**PUBLIC BUILDING COMMISSION OF CHICAGO**

**ADDENDUM NO. 2 TO JOC Task Order 05810-C1505D-001-000  
FOR  
Mt. Greenwood Annex Site Preparation**

**DATE:** November 22, 2010

**NOTICE OF CHANGES IN CONTRACT DOCUMENTS**

### PRTIAL CAISSON PLAN

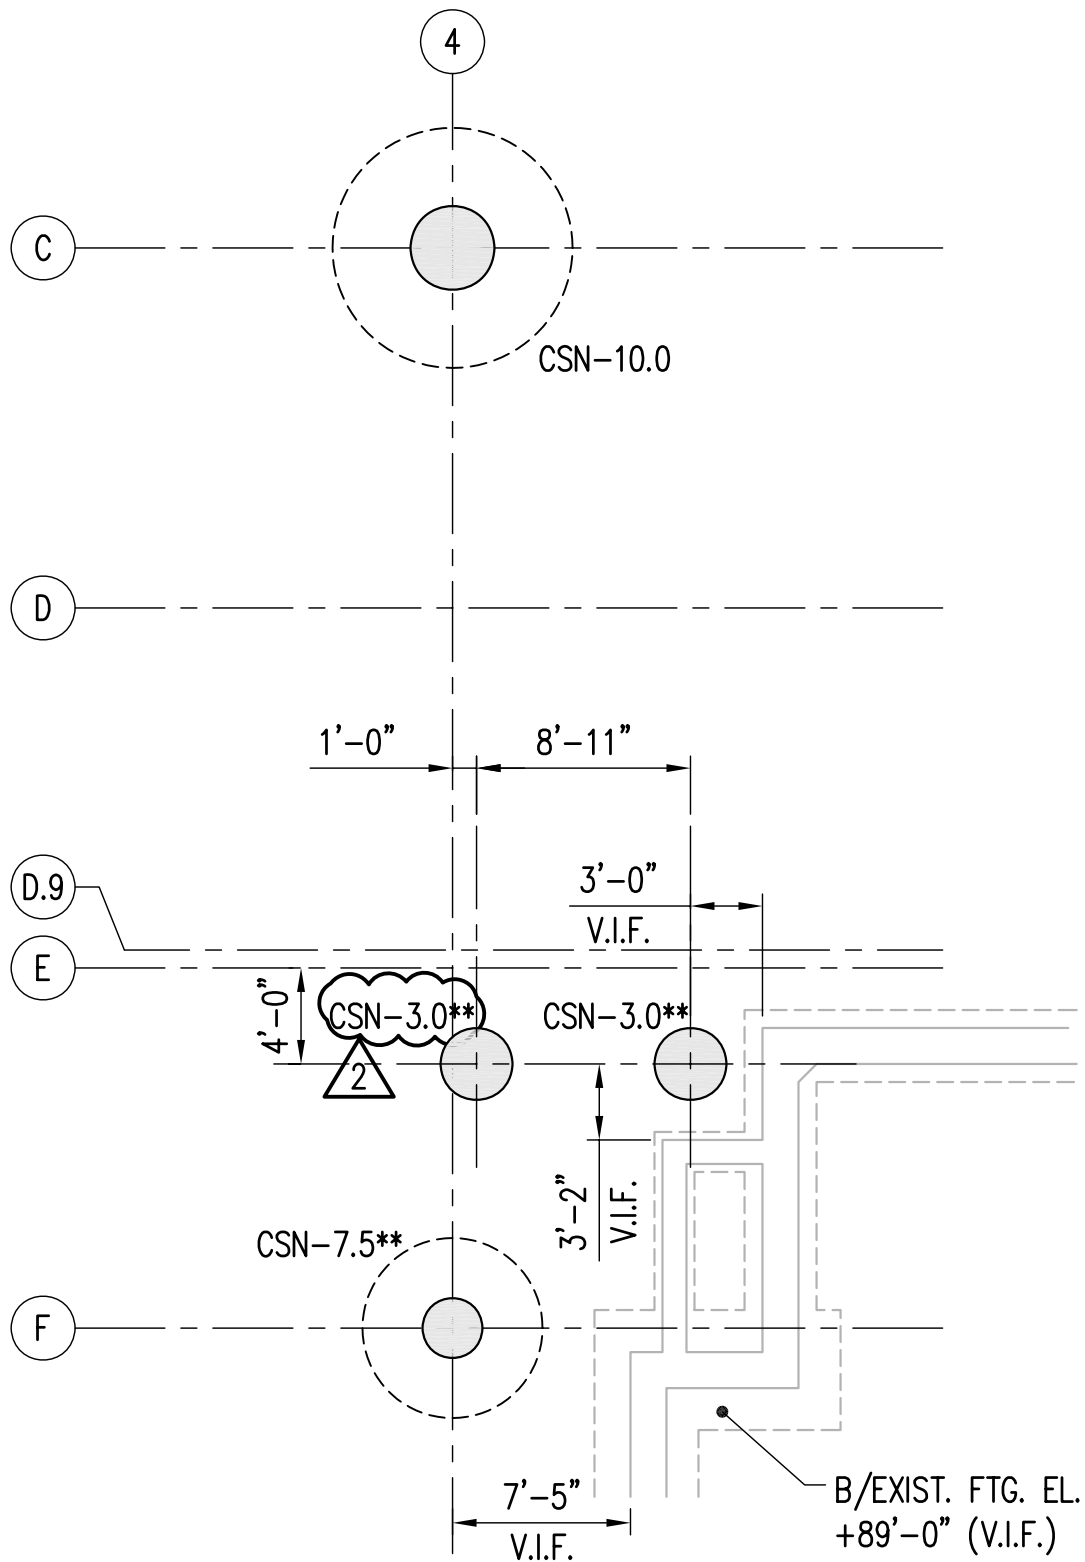
<b>Change 1:</b>	Provide a permanent steel casing in lieu of a temporary casing for one additional caisson near column line as indicated on the attached sketch
------------------	--
